DEVELOPMENT CONSENT  
Development Consent No. 1510875  
18 DEC 2014  
SUTHERLAND SHIRE COUNCIL

REVISIONS TO ADDRESS DEFERRED COMMENCEMENT CONDITIONS

PROJECT STATUS  
APPLICATION FOR DEVELOPMENT  
PROPOSED RESIDENTIAL UNIT DEVELOPMENT

ADDRESS  
10-14 MOANI AVE  
GYMEA  
CLIENT  
I J NORMAN NOMINEES Pty Ltd

## SECOND FLOOR (LEVEL 04) GENERAL PLAN

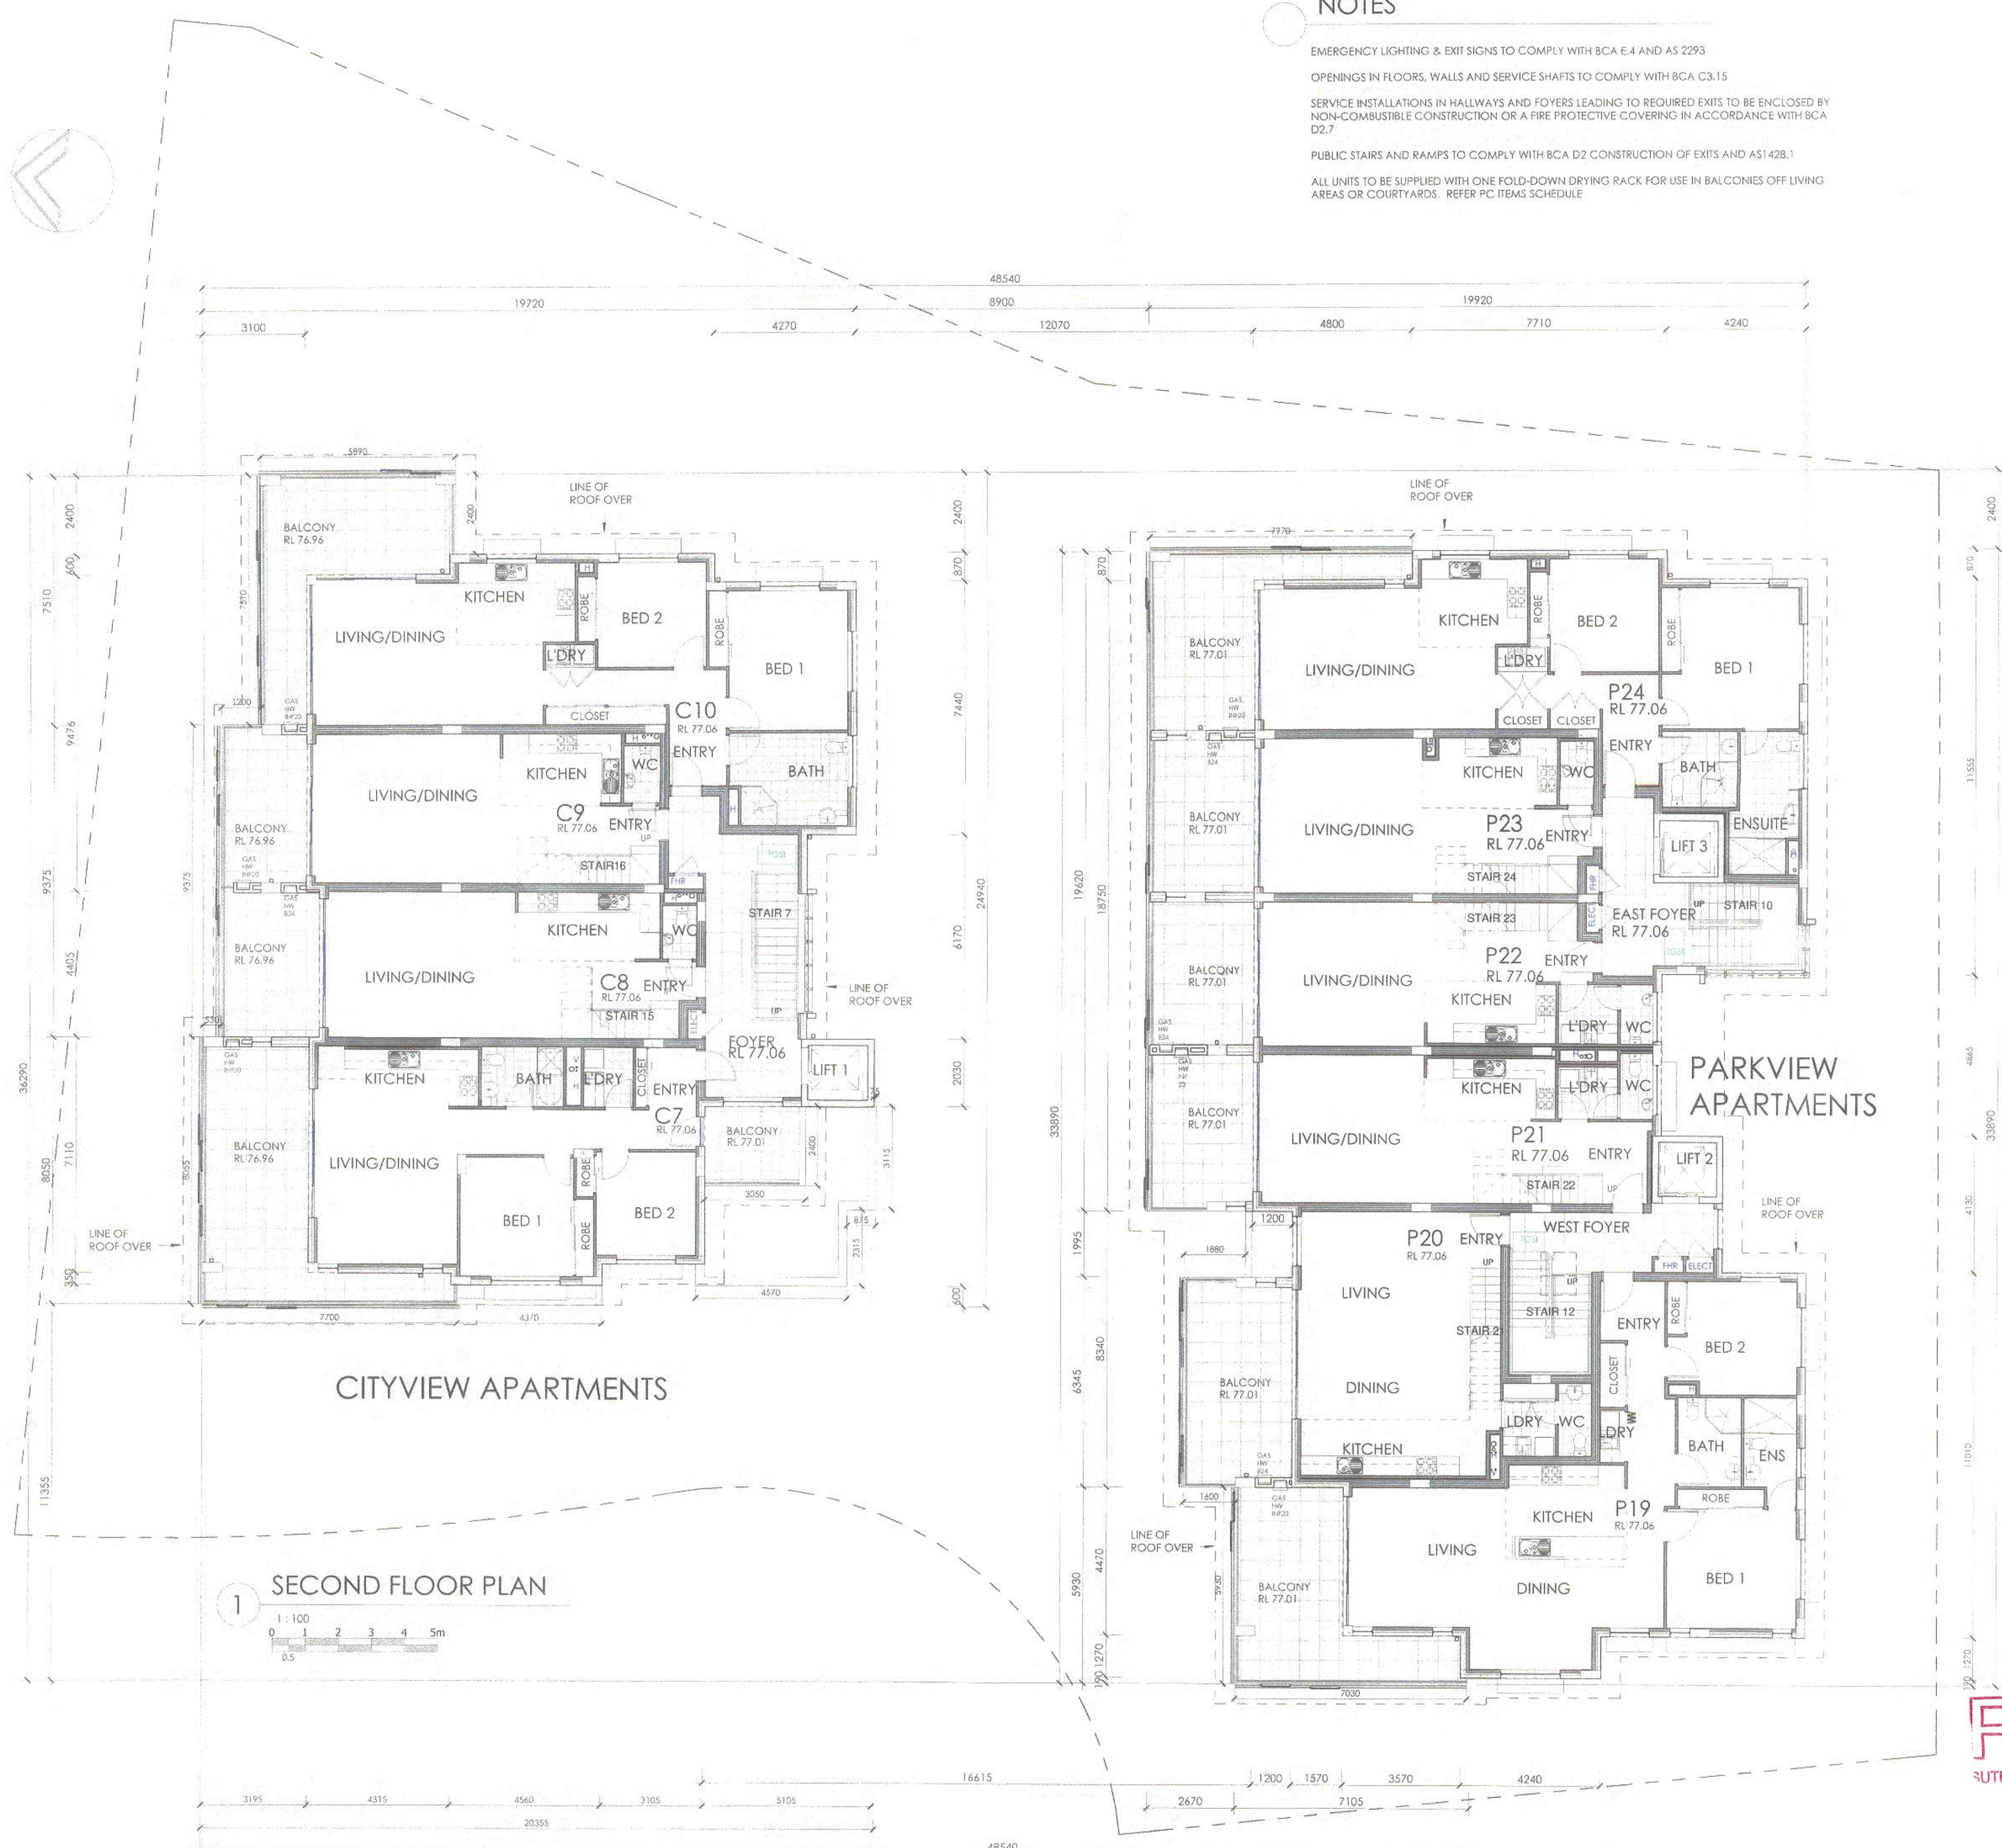
**Inclusion of a additional accessible carpark spaces.**  
An application to modify the development consent has been lodged to remove this condition, as it was included in the consent in error.

**Relocation of access space to ensure pedestrian safety around lift 3.**  
The access space has been relocated. The proposed lift 3 has the accessible space (5.0m x 2.0m) now adequately sized for maneuvering around the carpark space. The inclusion of a balcony at the entry of the lift ensures pedestrian safety. The revised carpark design has been certified in accordance with DA Consent Conditions 26, 41 and 42.

**Relocation of pedestrian entry.**  
The design of the entry has been modified in accordance with the accessibility standards at the lift meeting, but with further modifications in order to meet the level constraints in Council's design, requiring an additional rampway to meet the first landing of the required foot design level.

**Relocation of path and stairs to podium level.**  
The path and stairs have been relocated to be against the podium, and landscaping extended adjacent to the area.

**Relocation of path to carpark level.**  
The exterior path access has been amended to show a direct access to the carpark level.

**Relocation of podium level access.**  
The podium on the podium level has been extended to provide covered access between the Cityview and Parkview Buildings.

**Relocation of Carports P19, P20, P21, P22, P23, P24.**  
The podium level carports have been extended to 5m depth. Individual house privacy screens have been included on the rear wall of each carport to 1.8m high. Grassed garden planters have been provided in the carport area in front of each carport.

**Relocation of access to western external stairs.**  
The western external stairs have been moved north to align with path through podium terrace.

**Relocation of access to lift 3.**  
The access level of these apartments have been redesigned to locate the walkways between the bedroom and study, as shown on plans on external stairs.

**Relocation of access to lift 3 and lift 11.**  
The entry level of carpark level and podium level above and the approach to lift 12 have been redesigned in line with the lift meeting, with minor amendments to ensure accessibility. The design has been approved by Accessible Building Solutions (Access Consultants).
